Response to Submissions

St Aloysius College

State Significant Development Application SSDA 8669

29 Burton Street, Kirribilli
1-5 Jeffreys Street, Kirribilli
47 Upper Pitt Street, Kirribilli

Figure 1 | Eastern Elevation, Main Campus (Source: PMDL, 2018)

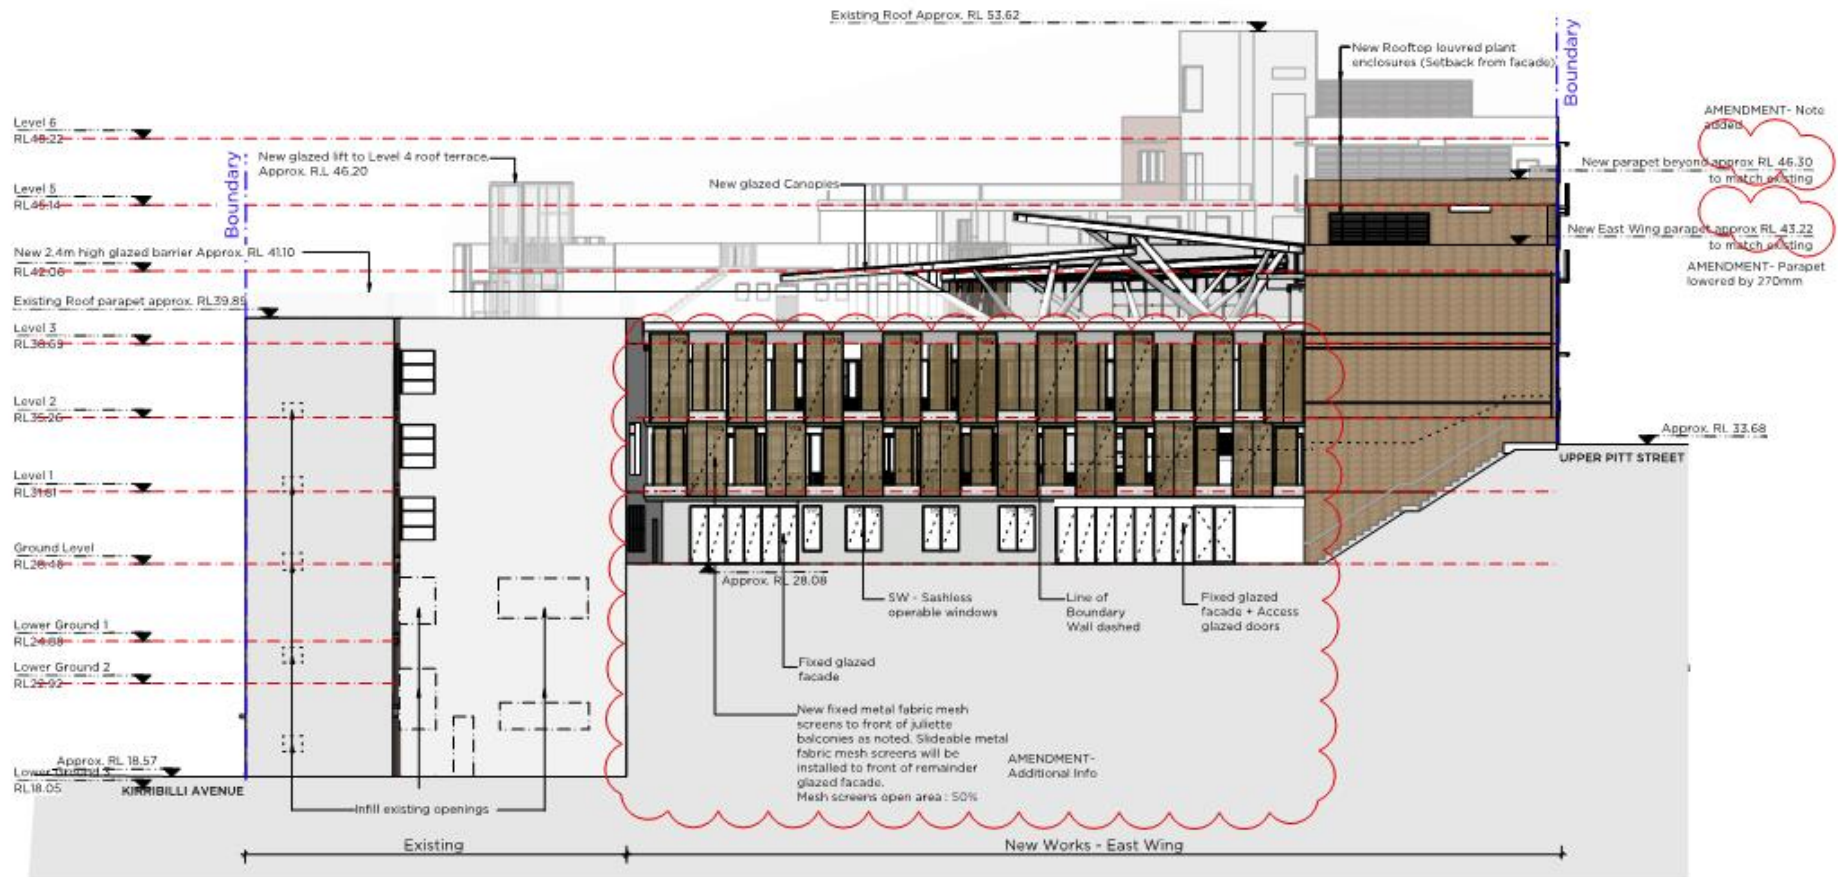
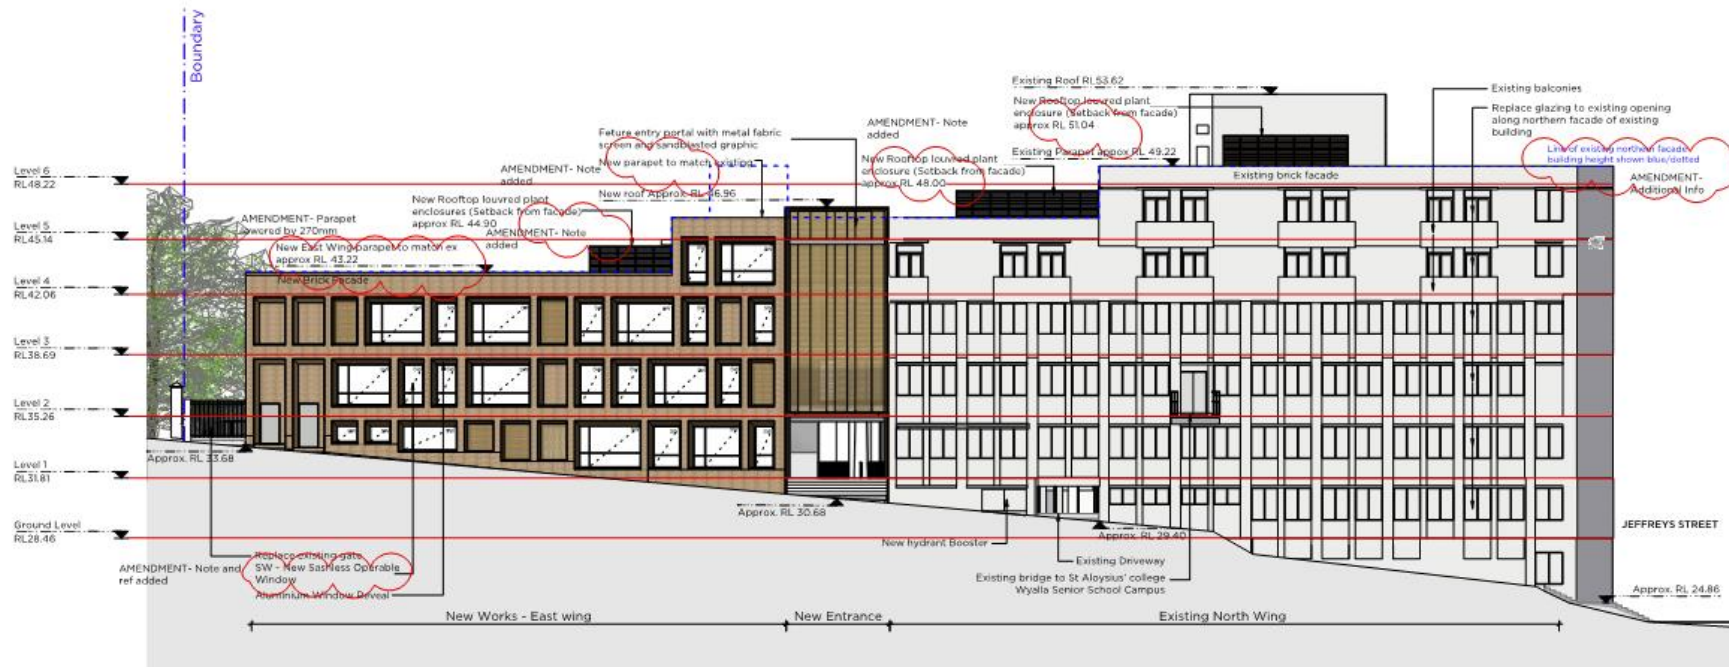
Figure 1 and **Figure 2** illustrate the siting of the proposed built form within the Main Campus. As evident, the proposed development will sit below the existing building height.

In addition, in light of the submissions received, the parapet height of the North-East Wing was reduced **270mm**. to retain the existing building height fronting Upper Pitt Street.

Figure 4 | Summary of Impact on Harbour View (Source: RobertsDay, 2018)

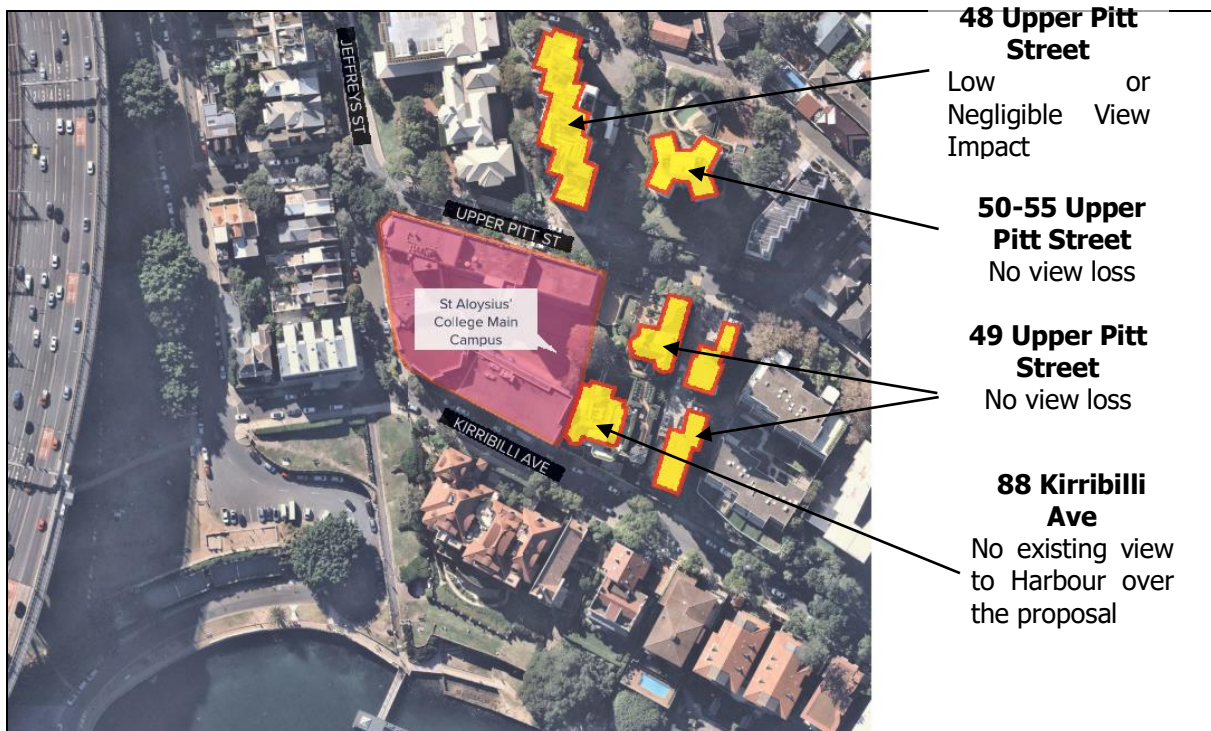
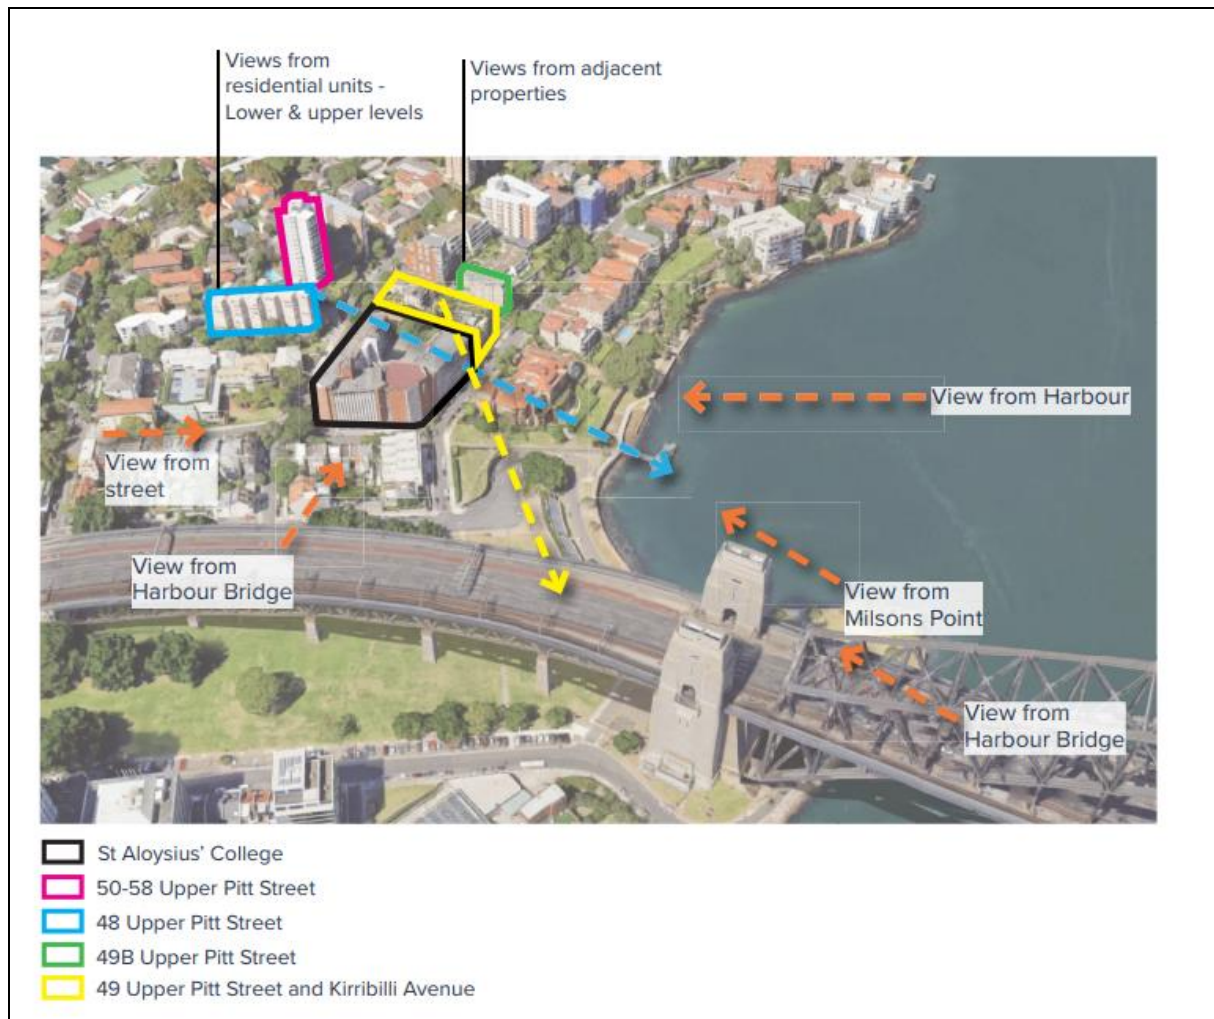
An amended Visual Impact Analysis has been prepared by RobertsDay and accompanies this RTS document as **Appendix E**. A selection of vantage points and a summary of the associated impact have been justified in detail and identified in **Figure 4** and **Figure 5** below.

RobertsDay has carefully studied **19** view points to identify any undue impacts on existing iconic views to the Opera House and Harbour Bridge from both public (eight (8) views) and private (ten (10) views) views. Additional view analyses from windows of habitable rooms in lower level apartments at No. 48 and 49 Upper Pitt Street have also been provided at the request of the DoPE. The photos were captured during Site visits performed in November 2017, July 2018 and October 2018.

Figure 8 | Existing – Unit 6, Level 2, 48 Upper Pitt Street

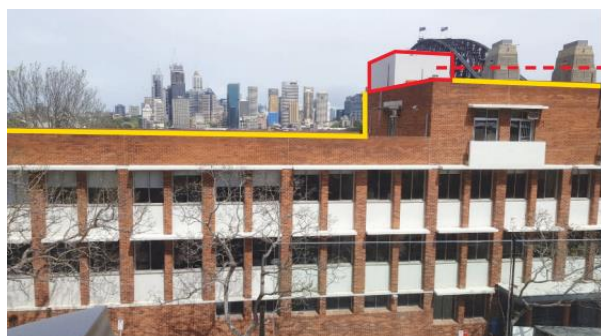
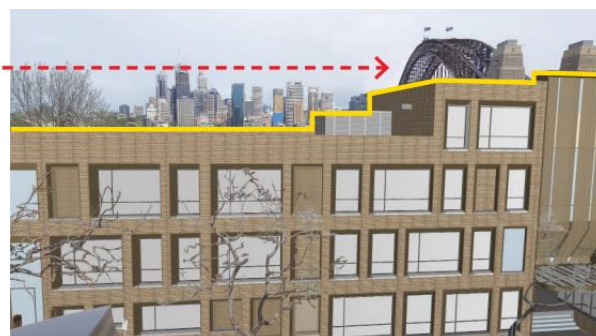
Views were taken from Level 2 Apartment, demonstrating the proposal in fact improves the view towards the iconic Sydney Harbour Bridge.

However, the removal of the existing stairwell will in fact improve the view, including that on lower levels, being Level 2 (Refer to **Figure 8** and **Figure 9**). The parapet height of the north-east wing fronting Upper Pitt Street has been reduced **270mm** to reflect the current parapet height, retaining the existing outlook across the north-east wing, apart from a minor intrusion of the proposed plant enclosure. Further, the iconic views of Harbour Bridge and Opera House will be retained.

Figure 22 | Existing View – Unit 501, 88 Kirribilli Avenue

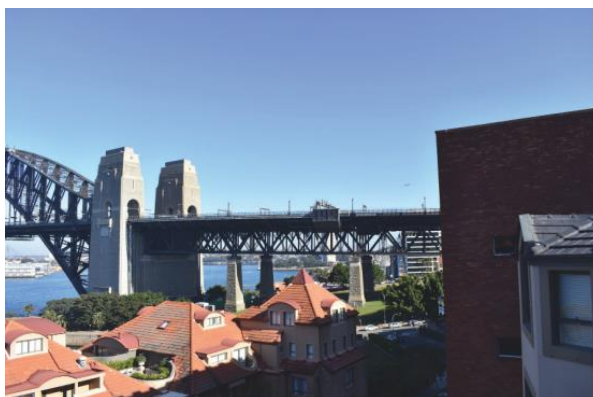
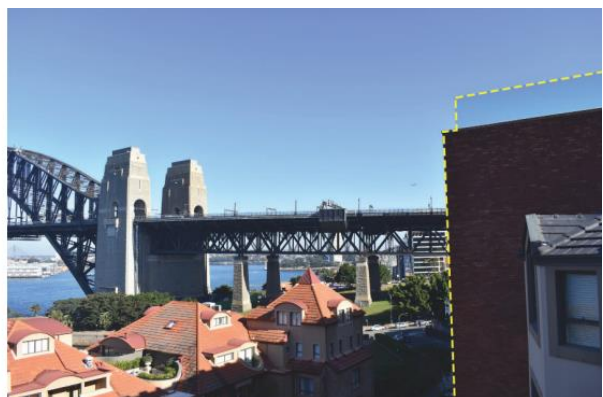
The proposal is located next to the apartment building, located at 88 Kirribilli Avenue. The proposal would see no change to the current views afforded at the lower levels of 88 Kirribilli Avenue, as there is no development immediately in front of the dwellings.

Despite the high sensitivity of the view, due to the proximity of the neighbouring property to the proposed development, the magnitude of the proposal in this view is considered negligible since the existing view is maintained. Therefore, this will result in a **NEGLIGIBLE** visual impact.

Figure 24 | Plan of Wyalla showing End of Trip Facilities

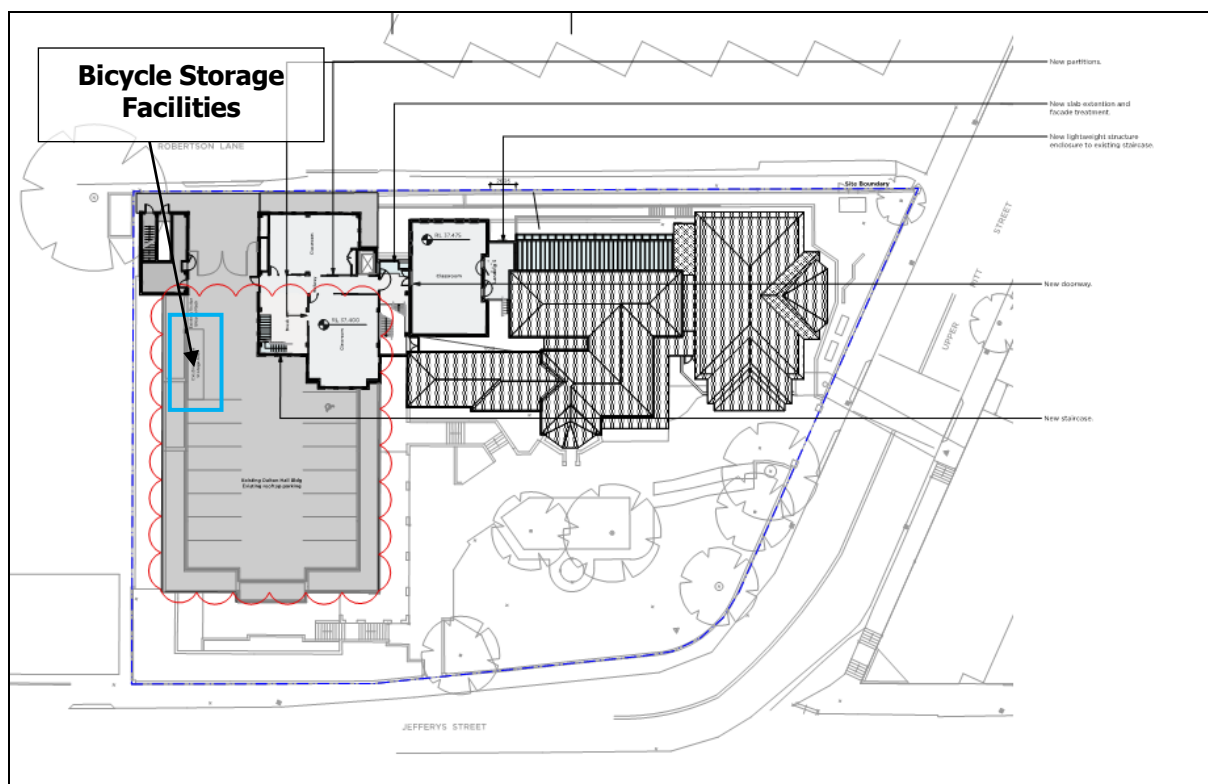
Bicycle storage facilities have been reinstated on Level 3 of Dalton Hall, adjacent to the existing rooftop parking, in accordance with the provisions of **DA-469/07**, approved by North Sydney Council. There are currently ten (10) bicycle storage facilities located on-site, including a visitor bicycle storage rack (refer to Drawing No. DAW123).

Figure 24 below shows the location of the bicycle storage facilities in relation to the Senior Campus.

Figure 25 | Level 1 Floor Plan Drawing No. DAU125 (Source PMDL, February 2018)

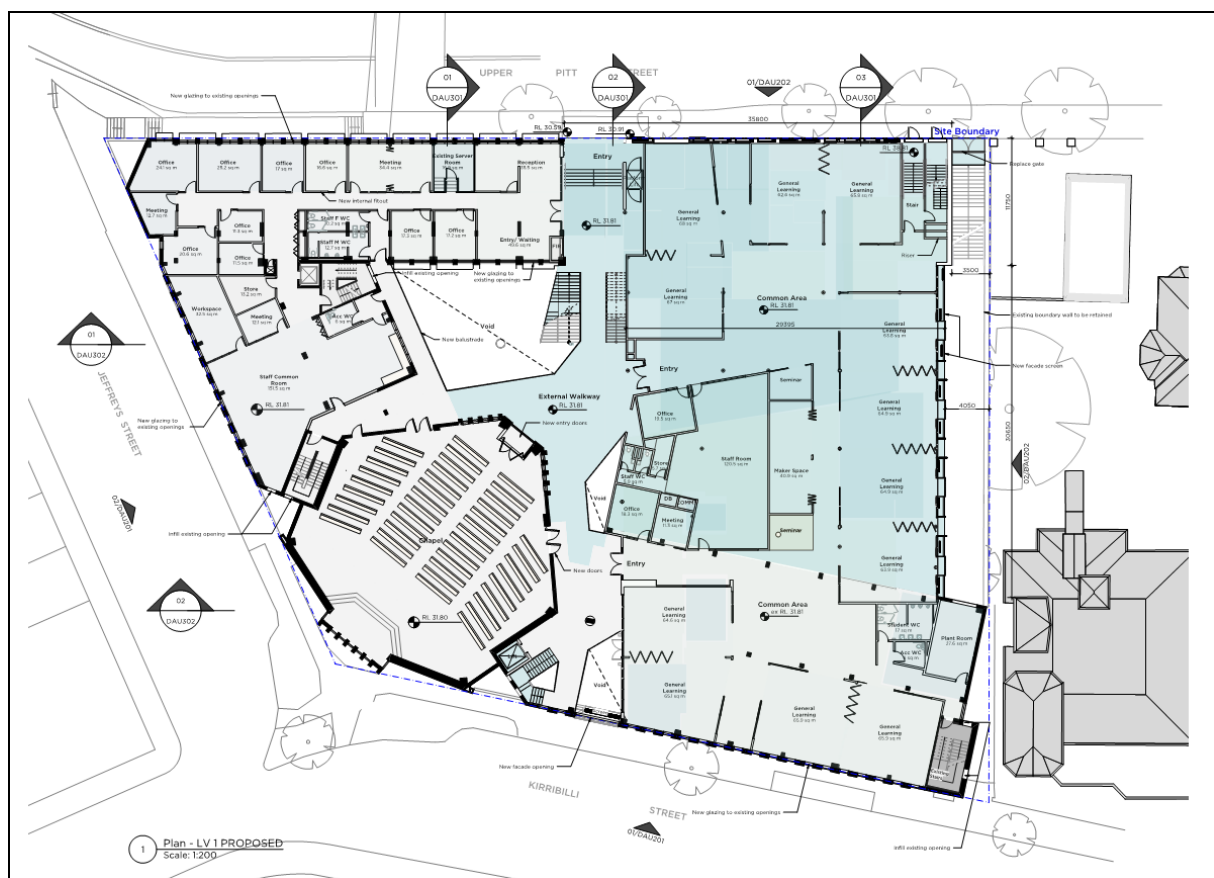
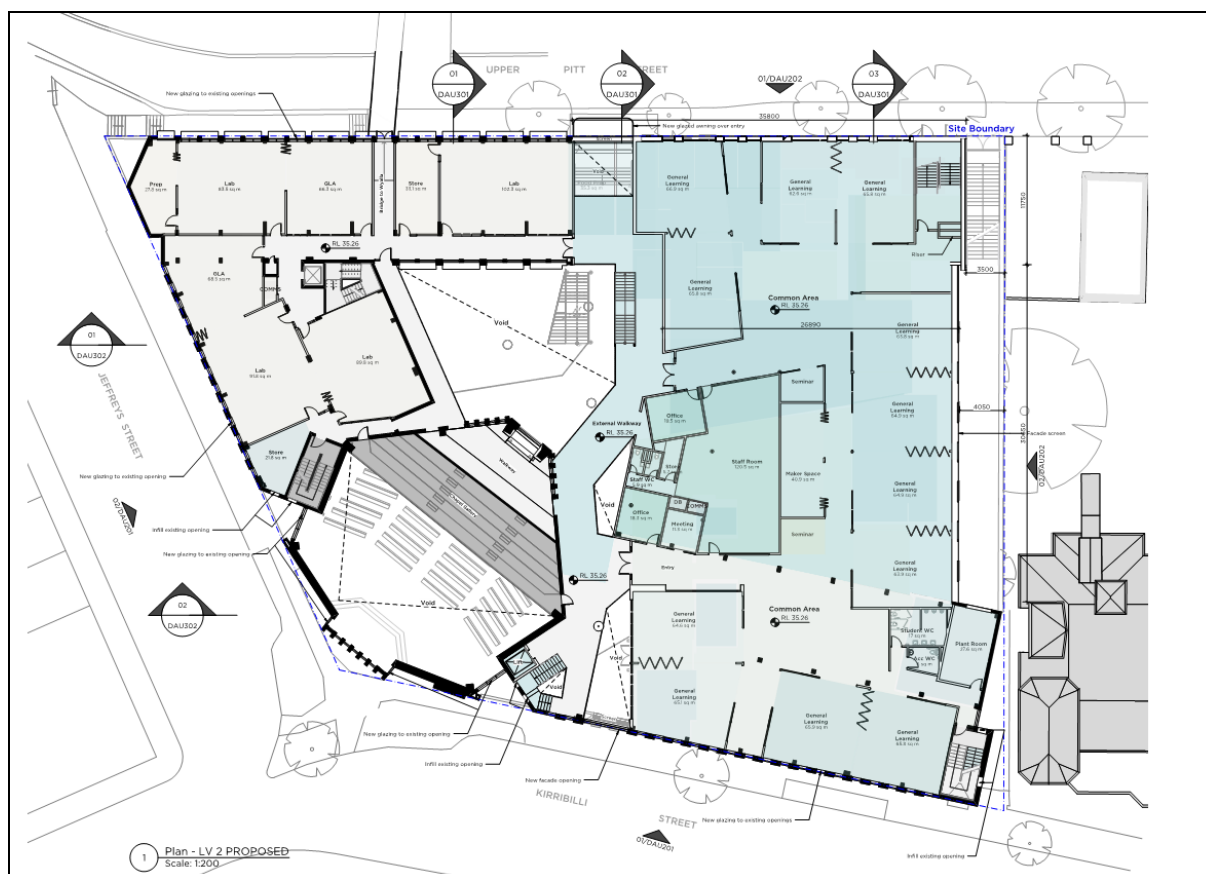
The design for the Main Campus therefore provides for six (6) general learning spaces which serve as home room for each of Years 7-10. These are indicated on drawings DAU125 and DAU126 and shown in **Figure 25** and **Figure 26** below.

The six (6) stream structure matches the current enrolment and structure, and is not designed to accommodate additional student enrolments.

Figure 27 | Section of Acoustic Barrier (Source: Wood & Grieve Engineers, 2018)

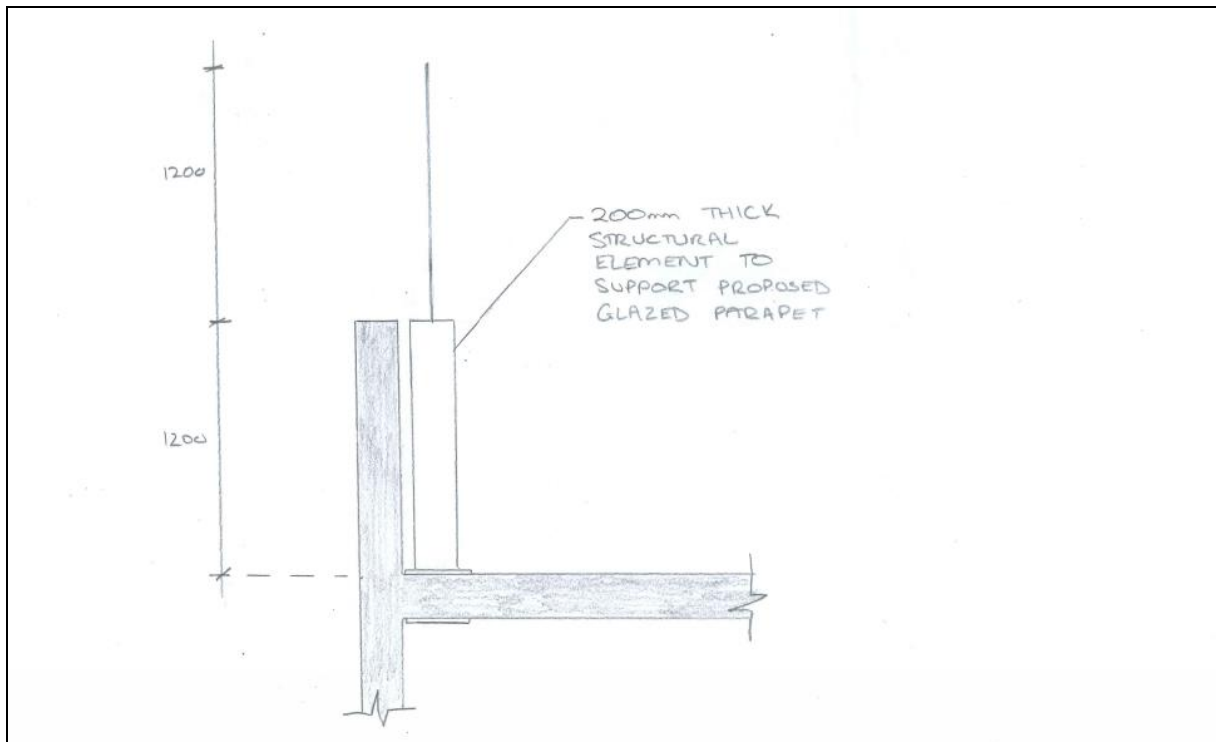
The most appropriate acoustic performance with respect to compliance is achieved through the use of an acoustic barrier with a minimum height of 2.1m. Any increase in height above 2.1m to an acoustic barrier will further decrease impacts.

A preliminary sketch of the design engineered balustrade accompanies this application as **Appendix K** and is illustrated in **Figure 27** below.
